E. Vented Top Cover Seal - MerCruiser 120-140-160 Models

E. VENTED TOP COVER SEAL - MerCruiser 120-140-160 Models

(Attach Bulletin Reference Sticker to Page 6A-19 of Your Service Manual)

Figure 1. Sealing Plug Installed

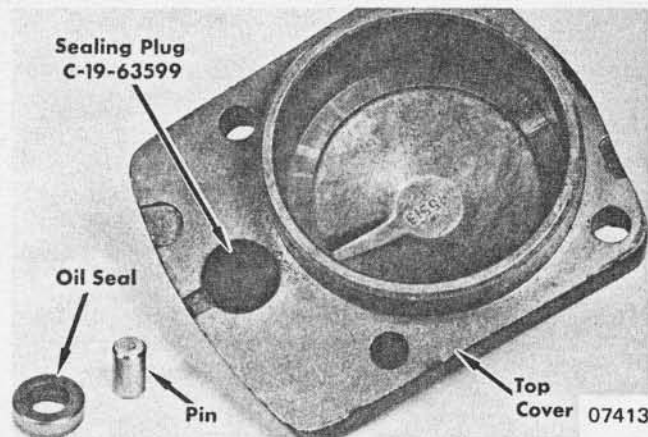
MerCruiser 120 and 140 Stern Drives (Serial No. 2062141 thru 2266775) and 160 Stern Drives (Serial No. 2065190 thru 2269838) were built with vented top cover assemblies.

Whenever these drives are serviced, we recommend removing the oil seal and pin from the cover and installing new sealing plug C-19-63599. (Figure 1)

Service replacement top cover assemblies will not be vented.

C-19-63599

Sealing Plug, Top Cover
